Final Environmental
Impact Report
J Street Drain Project
Ventura County, California
SCH # 2008041057

January 2012

ACRONYMS AND ABBREVIATIONS	viii
0.1 INTRODUCTION AND SUMMARY	0.1-1
0.2 CORRECTIONS AND ADDITIONS	0.2-1
0.2.1 REVISED AND SUPPLEMENTAL TEXT	0.2-1
0.2.2 REVISED AND SUPPLEMENTAL MITIGATION MEASURES	0.2-1

Surfside III Property
FIGURE 4.1-2

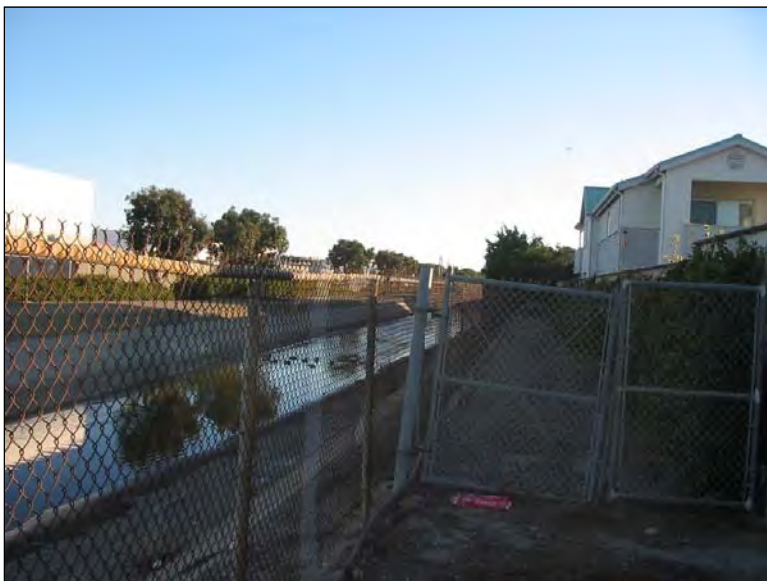
- 18-2 This comment expresses concern that Figure 4.1-2 referenced on page 4.1-6 does not show vegetation along the east boundary of the Surfside III property, which screens views of the Oxnard Waste Water Treatment Plant (OWWTP – please note this acronym is also defined in the Acronyms and Abbreviations section at the beginning of the EIR). Figure 4.1-2 is an aerial view of Surfside III, J Street Drain, and the OWWTP. On the aerial photo can be seen a line of landscaped vegetation between the Surfside III community and the OWWTP. This reference was intended to orient the reader geographically to the location of the landscaping in relation to residences and the OWWTP. Photograph 7 in Section 4.1 shows a ground view of the large trees along the east boundary of Surfside III, as seen from the lagoon.

A description of the existing setting is provided on page 4.1-6. As shown in Figure 4.1-2, a row of shrubs, mainly myoporum, and eucalyptus trees along the northeast boundary of the Surfside III property shields condominium residents on the east-facing sides of Buildings 15, 16, and 17 and users of the park immediately east of these buildings from views of the J Street Drain and the OWWTP east of the J Street Drain. Residents in Building 7, located nearest to the proposed project in the vicinity of the OWWTP, are shielded from the industrial view by a 100-foot-long section of approximately 14-foot-tall mesh-screen chain link fence on the west edge of the OWWTP property. This fence screens the view of the OWWTP maintenance yard. The remainder of the OWWTP south of the maintenance yard is screened by trees and shrubs along the plant's west property boundary. Sparser vegetation along the east boundary of the Surfside III property from Building 7 southward forms an inconsistent visual barrier, and residents in Buildings 6 and 7 are able to see the J Street Drain from their dwellings.
